MINNESOTA DEPARTMENT OF PUBLIC SAFETY
State Fire Marshal Division
Interpretation

Interpretation # INTERP FP 12 (2007)	Subject of Interpretation: Design criteria for multiple spray booths		
Reviewed and Approved By: Jerry Rosendahl	Title: State Fire Marshal	Effective Date: July 10, 2007	Revision: July 10, 2007

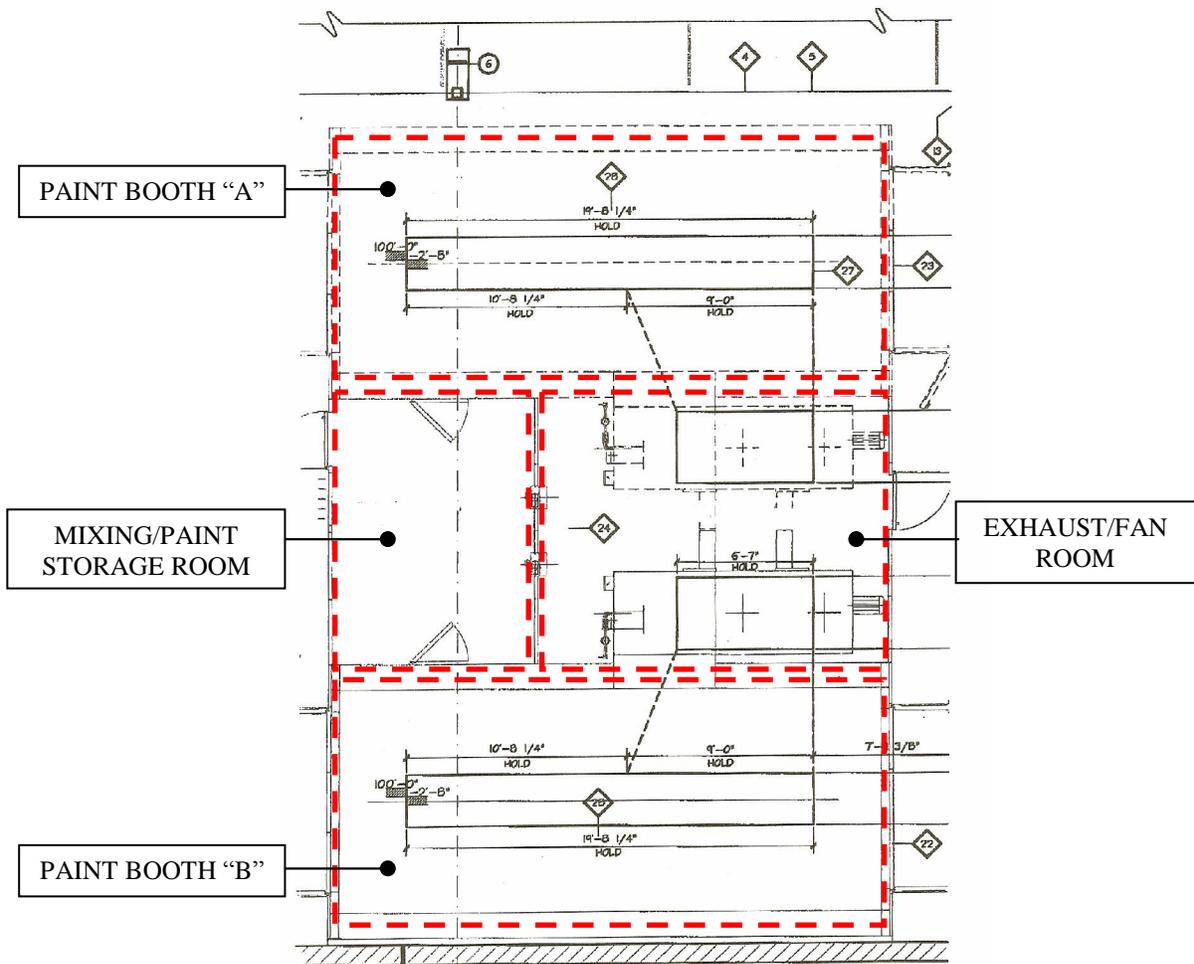
A number of questions have been submitted to the State Fire Marshal Division – Fire Protection Section regarding the design criteria for multiple attached/adjacent spray booths. The following floor plan serves as an example:

Question #2: Do I calculate only one booth at a time or do I calculate the entire spray area as an Extra Hazard Group 2, 0.4/2000 (in this case the full 1080 sq. ft.)?

Answer: Design the hydraulically most demanding single booth and associated exhaust ductwork to Extra Hazard Group 2. The single booth calculations are independent and do not have to be added to the overhead system calculations.

Attached booths with openings in common wall(s) are considered as one single booth. Example: Two booths have a common wall with a walk-thru opening. The “door” of the opening consists of strips of heavy plastic material commonly found in coolers and freezers. For calculation purposes the entire area of both booths shall be considered as one booth. If the “door” of the opening is of material consistent with the remainder of the booth, for calculation purposes this would be considered as two independent booths.
